AGENDA

PLANNING AND ZONING COMMISSION MEETING

CITY OF CREVE COEUR, MISSOURI

MONDAY, MAY 20, 2019

Figure 5: Close-up of the proposed new front entrance.

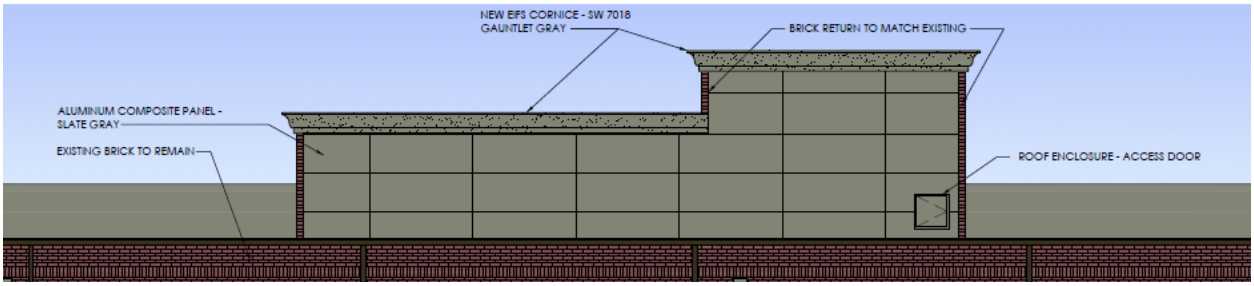
The Applicants have revised the elevations to maintain the two tower elements, reducing the large expanse of the area to the right of the entrance, and extending the windows above the canopy. The Bark "wood" panels have been eliminated, and replaced with slate gray aluminum composite materials. The bright silver aluminum composite panels remain over the entrance tower. The triangle parapet over the adjacent tenants will be removed to create a more cohesive design in consideration of the prior discussion for the entire center. The Applicants will have material samples available at the meeting.

Staff believes that the changes to the design and materials of the building address the Commission's comments from the previous meeting. The large expanse of bright aluminum panels has been eliminated and now features a darker color and the taller windows also help to bring greater articulation of the façade. The design is more simplistic than the previous version; however, staff believes this approach is more proportional to the overall façade of the shopping center. Commission should review the materials samples and discuss the overall design with the Applicant at the meeting. Any modifications to the

Figure 11: Close-up of the SDP showing the modular block walls on the west side of the building and on the adjacent property.

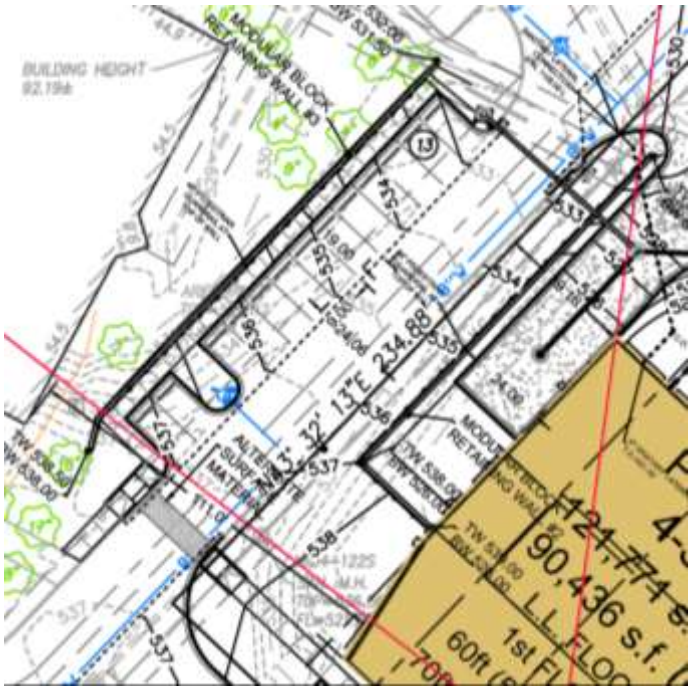
The Applicant has appropriately placed the loading areas to comply with these recommendations. They will also be completing some parking improvements on the adjacent property that will have a retaining wall. Details of these have not been submitted, however they have indicated that they will utilize the same material and color as the other retaining walls behind the retail center at West Park. Staff has included a condition of approval that the retaining walls and trash enclosures be of a material consistent with the existing similar elements in West Park Development.

Figure 13: Close-up of Cross Section C-C showing the sky exposure plane.

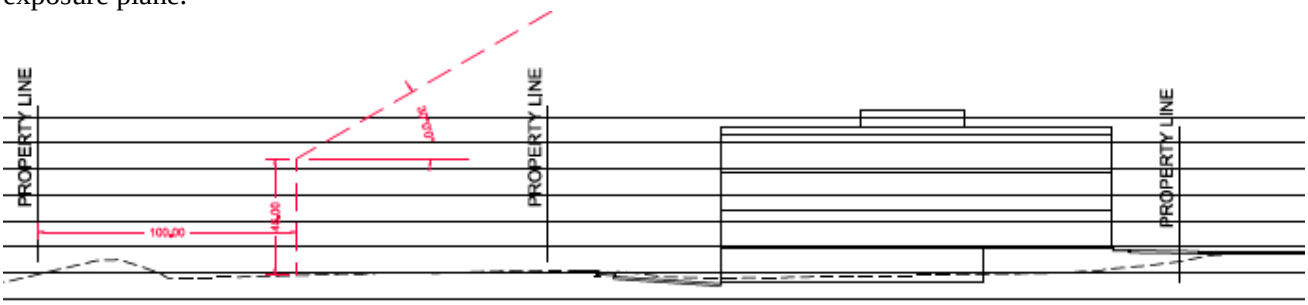
The proposed building has four floors on the north elevation and, three floors on the south, and approximately 70 feet in total height to the top of the rooftop screening. The gross floor area is 121,771 square feet, where the useable space, excluding common areas, hallways, etc. is 90,436. The property to the north is in unincorporated St. Louis County and includes multi-family and single family residential. The Applicant has provided a cross section of the building showing that it will meet with the sky exposure plane.

Figure 13: Close-up of the Applicant Landscape Plan, and the Landscape recommendation from 39N and the Old Olive Street Road Design (on right)

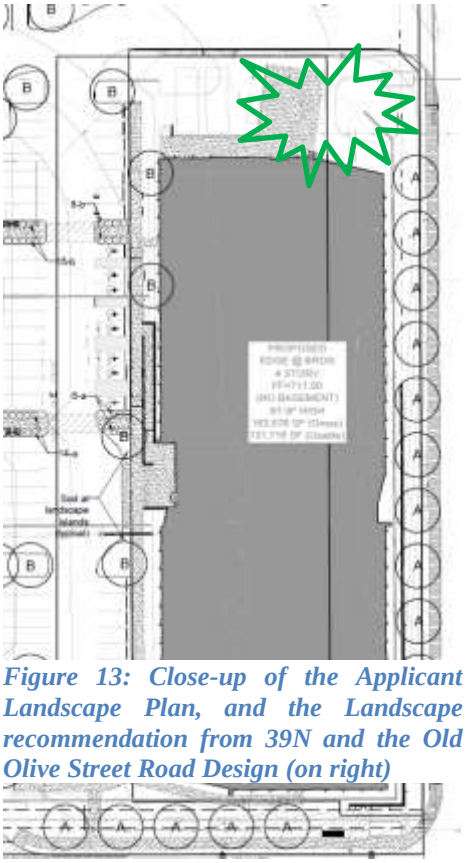
As discussed above, the 39N Master Plan promotes the use of native grasses and trees and incorporating this character feature throughout the area. The City's Design Guidelines strongly encourage high quality landscaping that accentuates the building and site, and softens the effects of parking area. All landscaping plans should exhibit a clear design concept. The building should be incorporated into the landscape design; and there should be a consistency of design throughout a development (p. 15). The proposed landscape lacks the cohesive design with the same variety or detail as recommended by the Design Guidelines and the 39N Master Plan. Incorporating some design elements and similar plant materials as found elsewhere on the Danforth campus is recommended. Further, additional plant material is needed adjacent to the building on both sides to soften the building.

Figure 14: Close-up of the Cross-Section C-C showing the sky exposure plane to the property to the north.

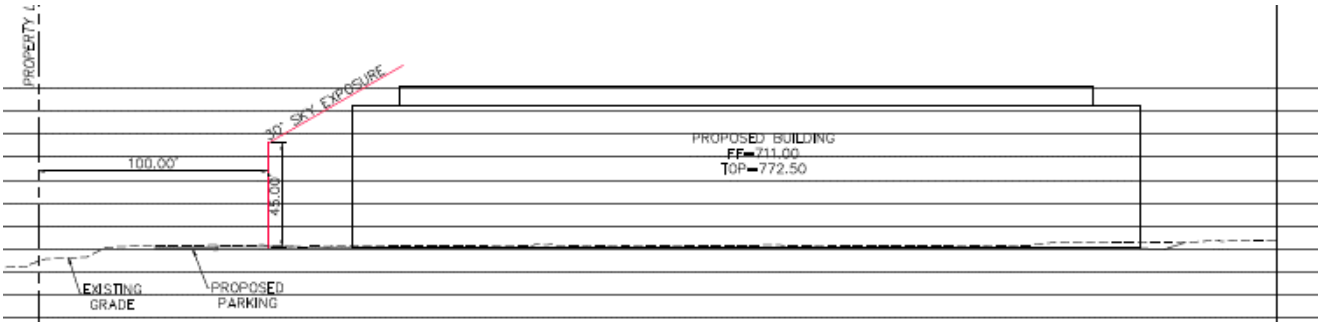
The proposed building is four floors, with a total height of 61.5 feet. The property to the north is zoned AR-Attached Single Family Residential. The Applicant has provided a cross section of the building showing that it will meet with the sky exposure plane.
